R. E. GINNA NUCLEAR POWER PLANT

AMENDMENT TO PROVISIONAL OPERATING LICENSE

Amendment No. 38
License No. DPR-18

ATTACHMENT TO LICENSE AMENDMENT NO. 38
PROVISIONAL OPERATING LICENSE NO. DPR-18
DOCKET NO. 50-244

FIG. 2.3-1

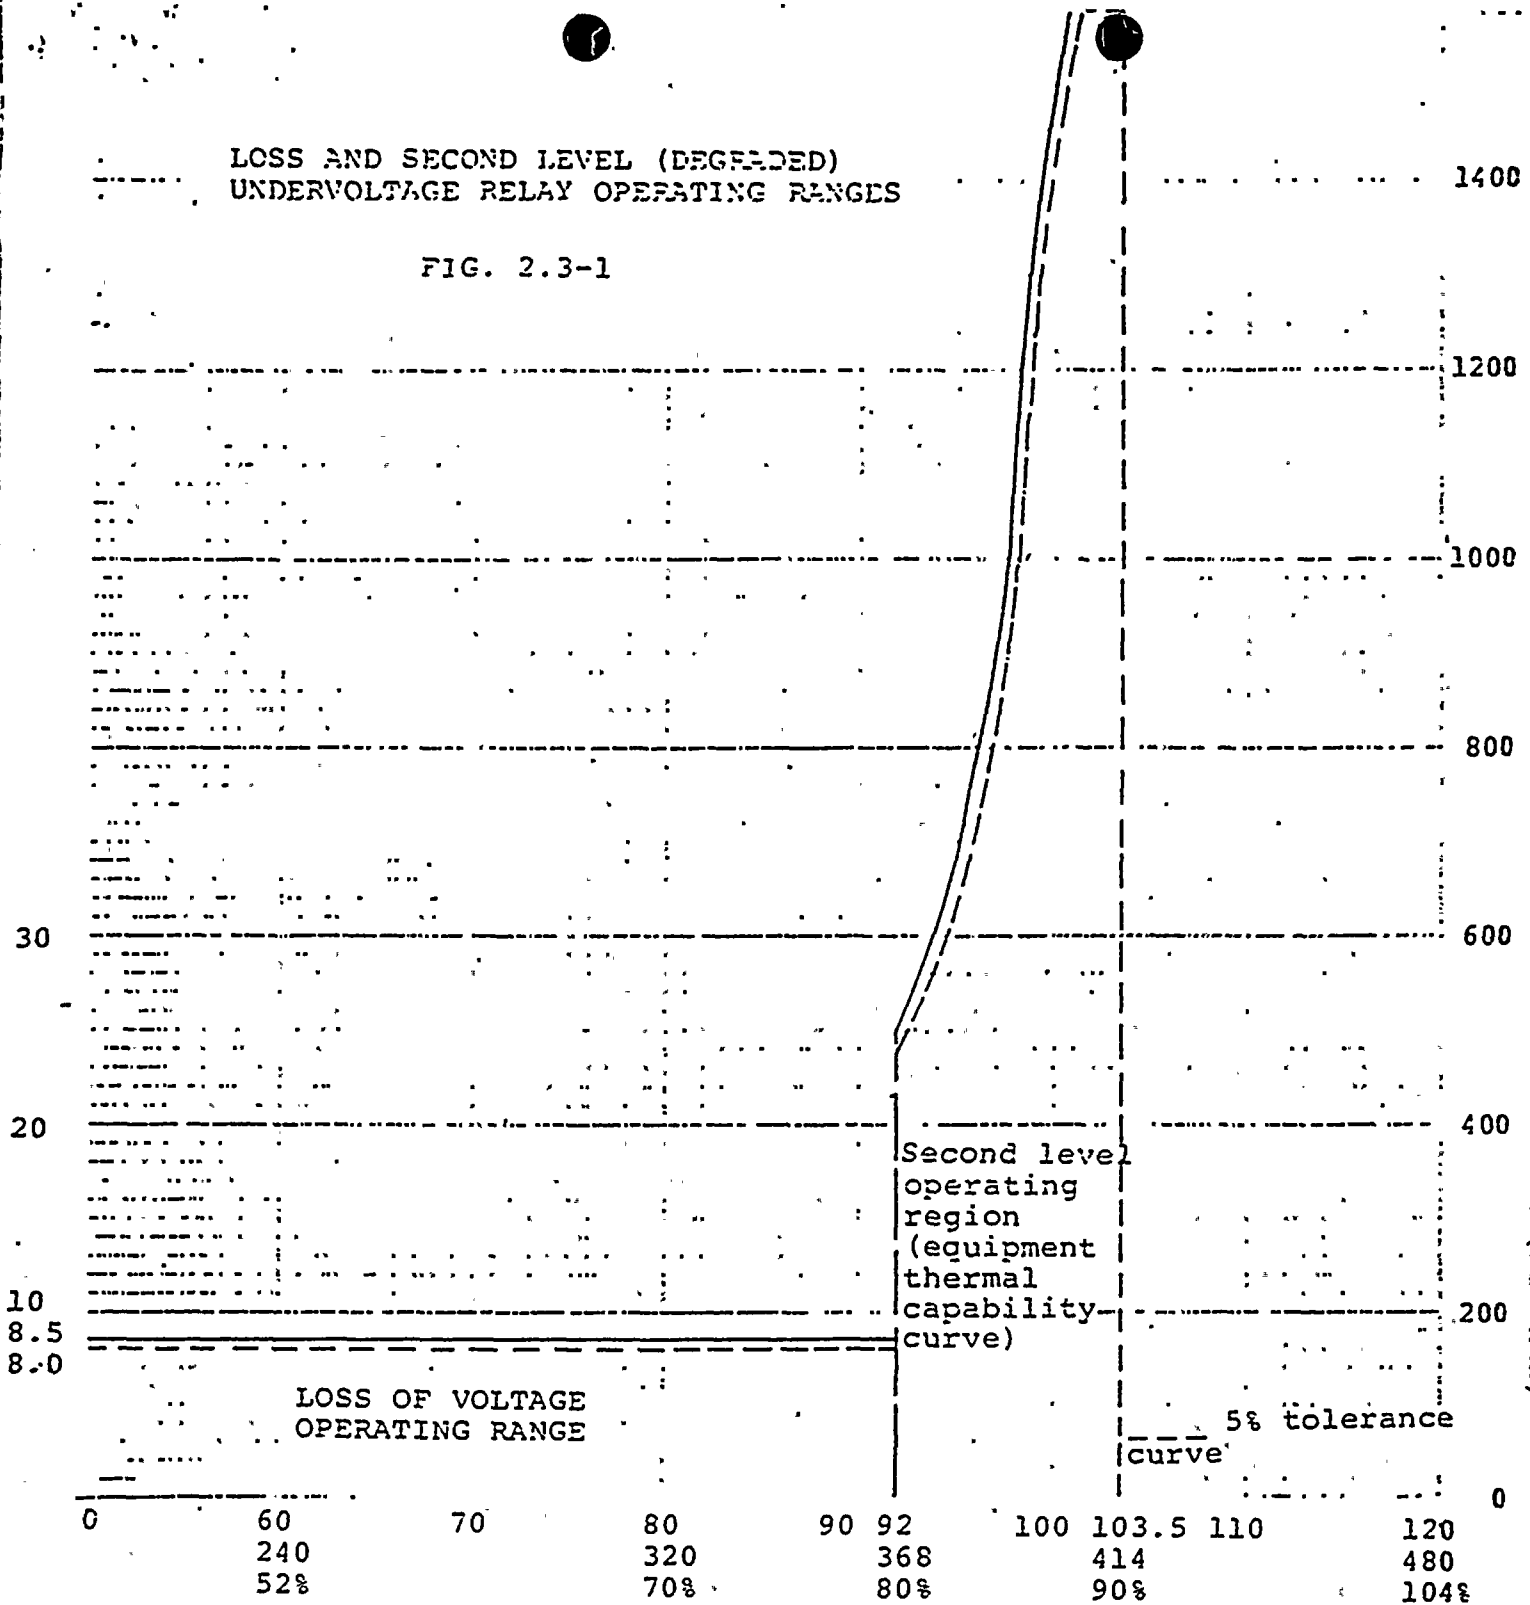
Measured values shall fall at least 5% below the theoretical limit. This 5% margin is shown as the 5% tolerance curve in Figure 2.3-1.

2.3.3.2 Acceptable degraded voltage relay operating times and setpoints, for 480 volt safeguards bus voltages \leq 414 volts and $>$ 368 volts are defined by the safeguard equipment thermal capability curve shown in Figure 2.3-1. Measured values shall fall at least 5% below the theoretical limit. This 5% margin is shown as the 5% tolerance curve in Figure 2.3-1.

The 5% tolerance curve in Figure 2.3-1 and the requirements of specifications 2.3.3.1 and 2.3.3.2 include 5% allowance for measurement error. Thus, providing the measurement error is less than 5%, measured values may be directly compared to the curve. If measurement error exceeds 5%, appropriate allowance shall be made.
